ADDENDUM 01

Addendum to the drawings and specifications for:
Kendall County – Emergency Medical Services Station No. 3

EMERGENCY MEDICAL SERVICES STATION NO.3

10.06.23

KEYED NOTES: (THIS SHEET ONLY)

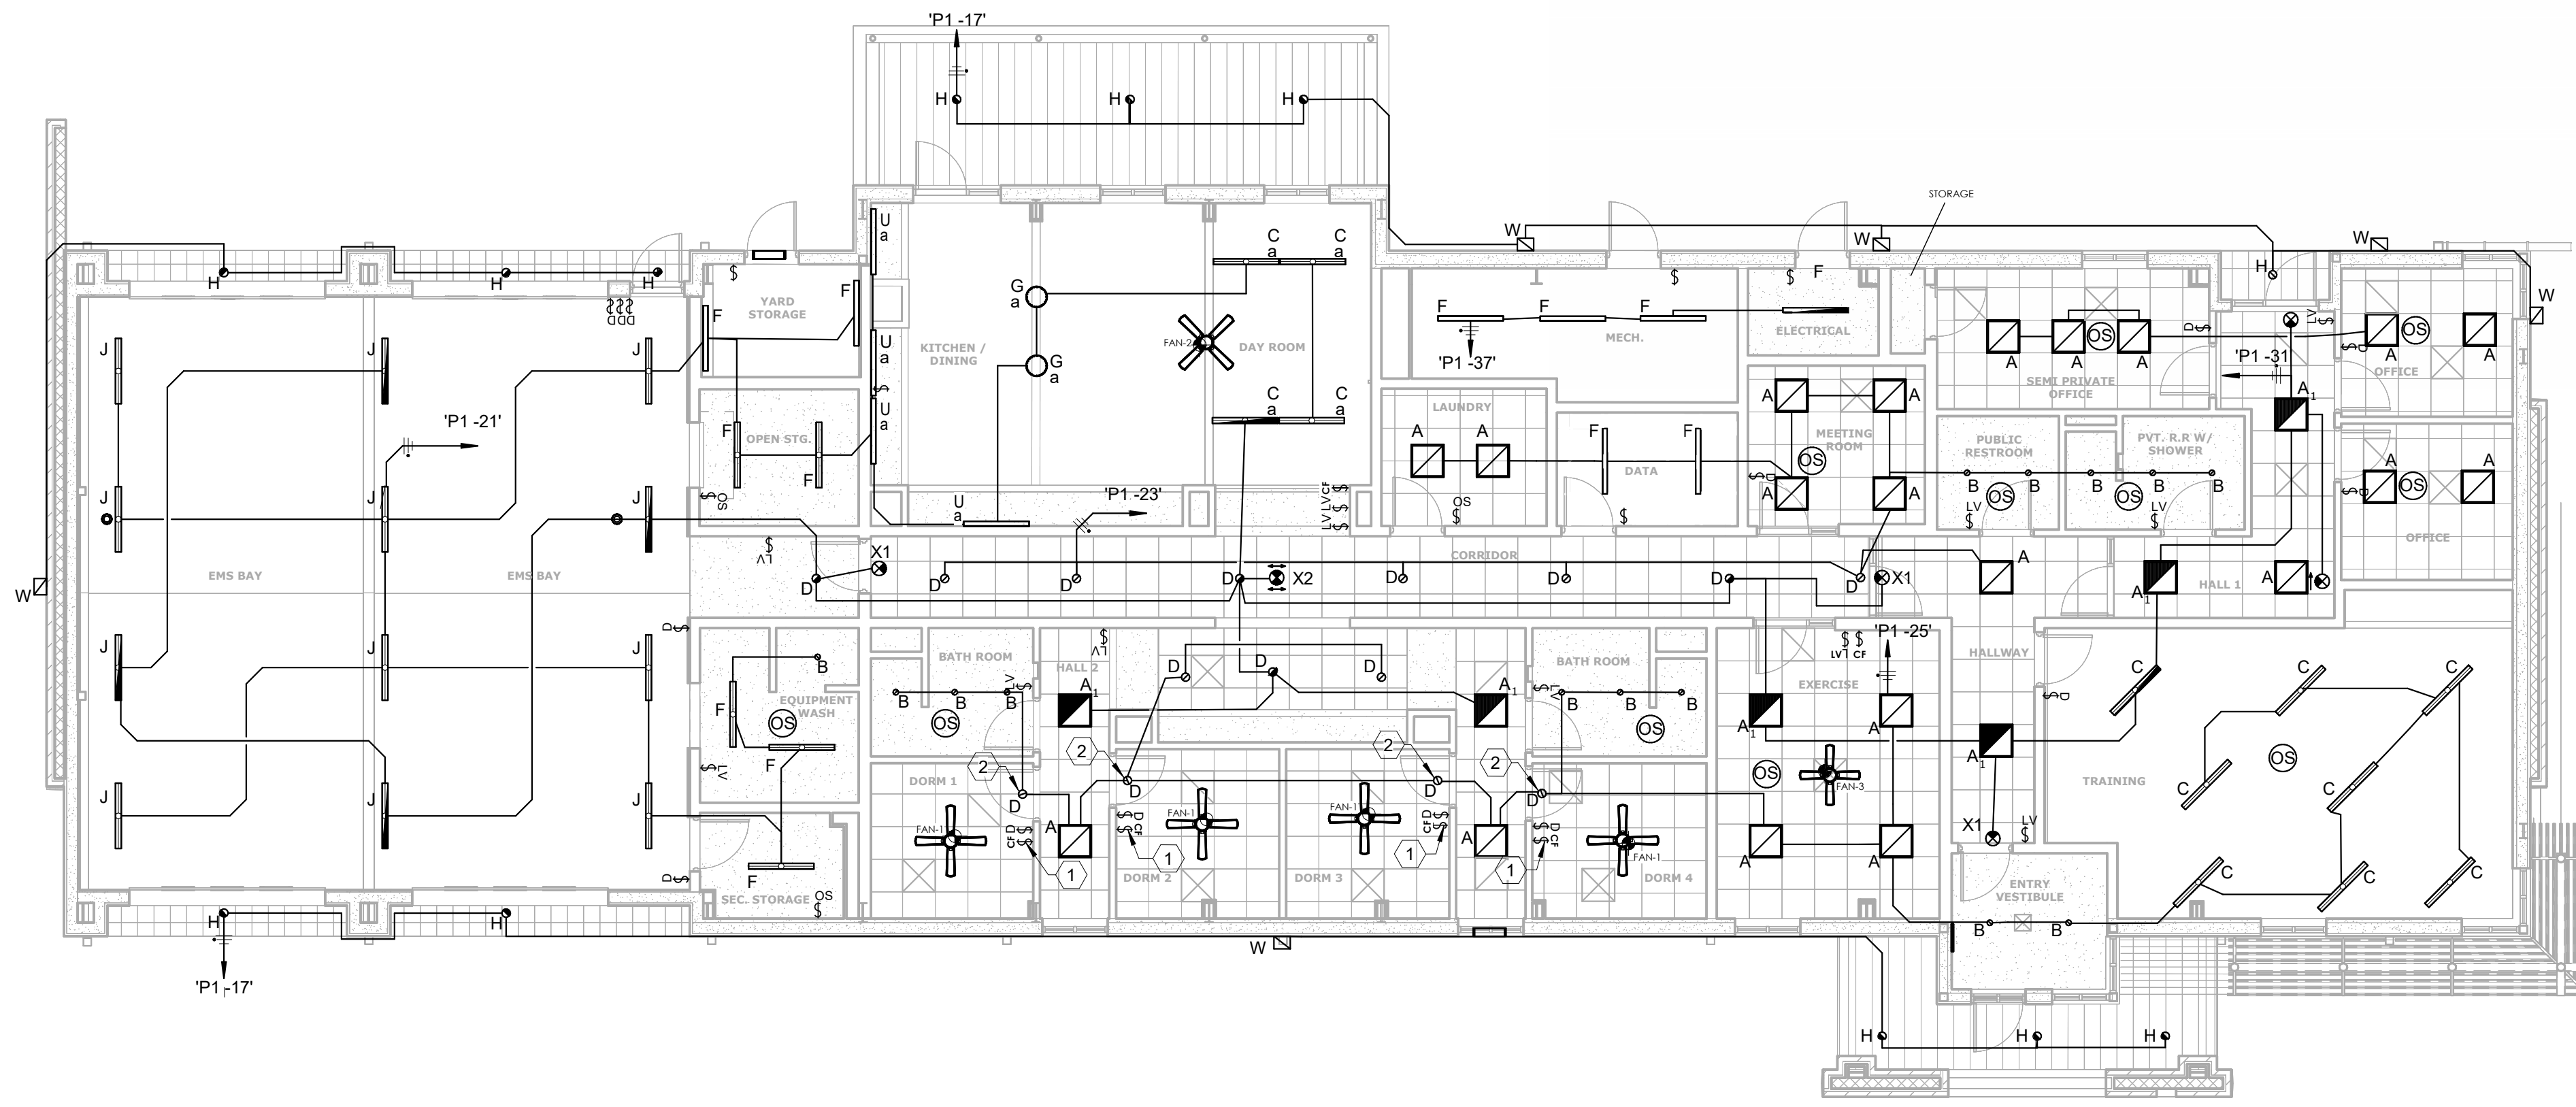
- Item 1: Modified exterior EMS Bay downlights.
- Item 2: Modified lighting in Mechanical and Electrical Room, laundry room, and the kitchen.
- Item 3: Added Ceiling Fan circuits to lighting plan.

22. Question : There are a number of downlights not identified in reference to E2.1. Also 2 – type 'B' in training room not circuited?

Response to Question 22 : Refer to the revised sheet E2.1

1 ELECTRICAL SEPTIC EQUIPMENT RACK DETAIL
NOT-TO-SCALE

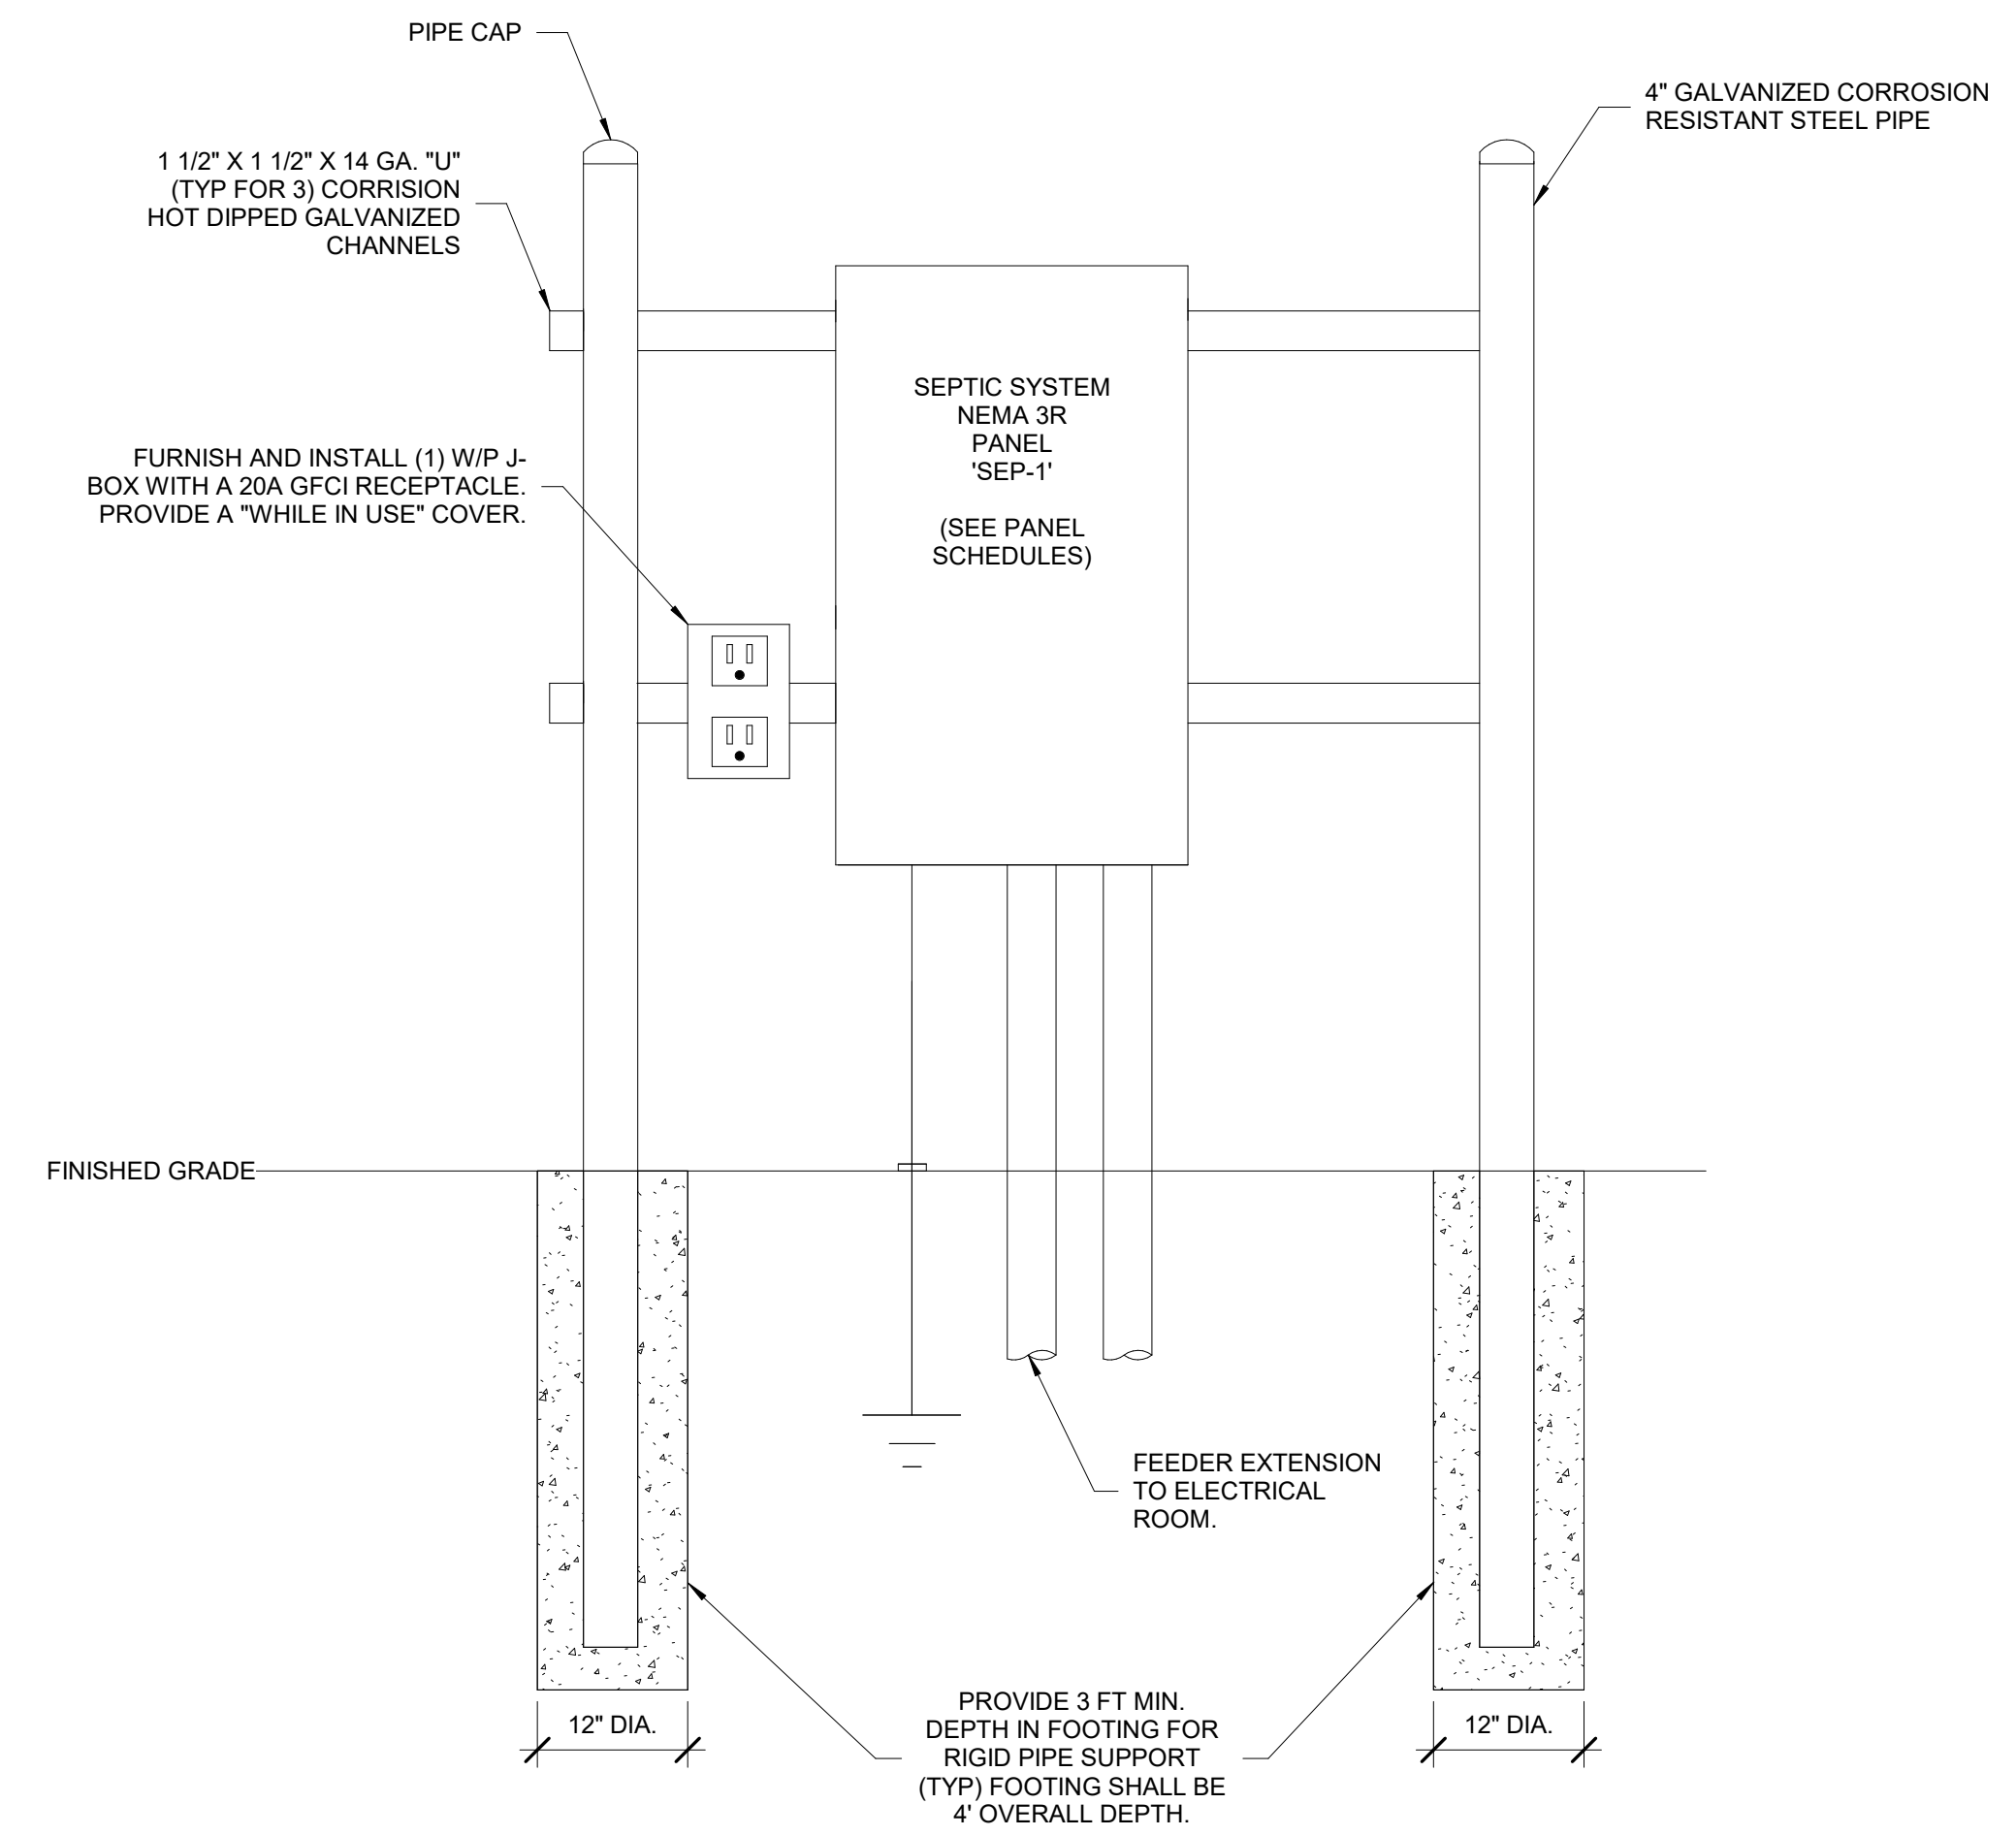
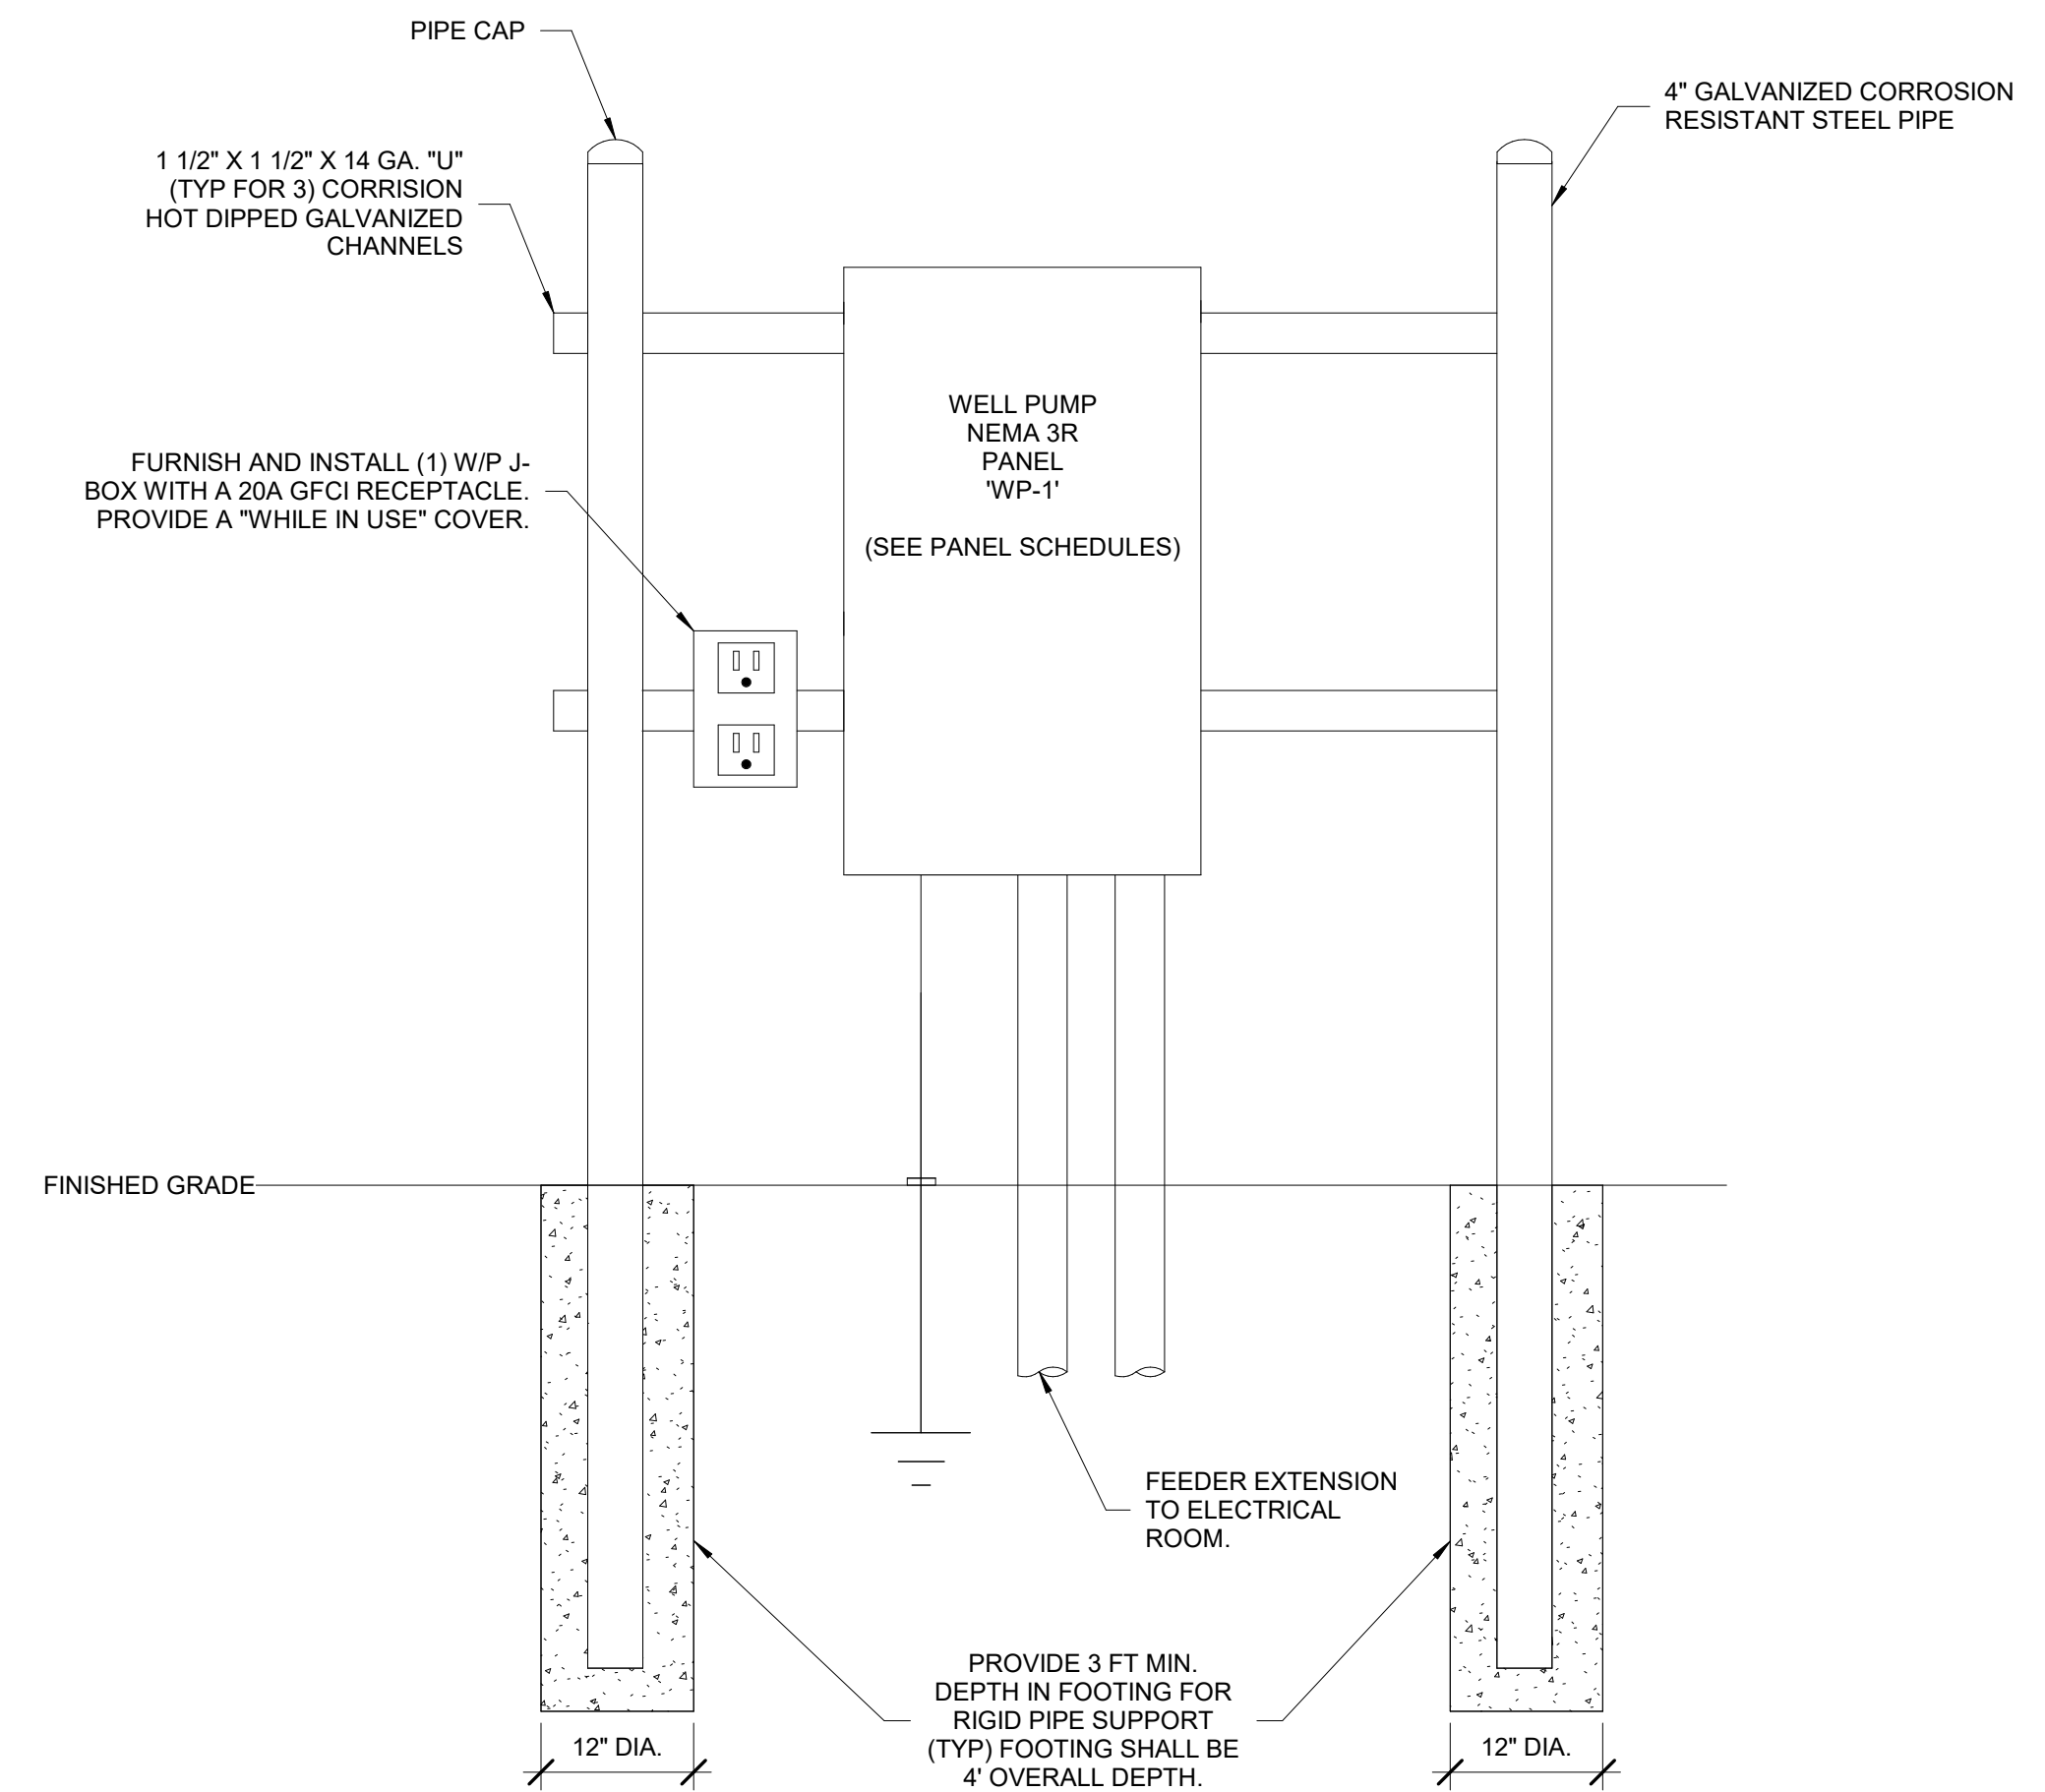
- Item 1: Added Well Pump Panel (WP-1) rack detail.
- Item 2: Added Septic Panel (SEP-1) rack detail.
